## RF EXPOSURE INFORMATION

**RE: Certification Application**

FCC ID: 2ACBR-GR1 Model: GR-1.5-915 IC: 12120A-GR1

Figure 1 - Measurement from closest point the hand might contact the enclosure to the radiating structure on the antenna

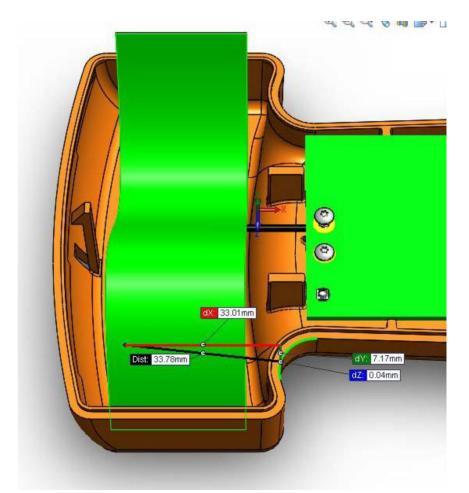
Based upon the information provided, even if 1.6W/kg were used during the computation of the formula found in KDB Publication 447498 D01 4.3.2(2) and the duty factor was not considered, the simultaneous value would be:

[(631 mW/32 mm)\*sqrt(0.92775 GHz)/18.75] + 1.6 W/kg = 2.61 < 4.0 W/kg, thus satisfying the simultaneous transmission SAR test exclusion consideration given in 4.3.2 of the aforementioned publication.

This following drawings support the 32mm separation:
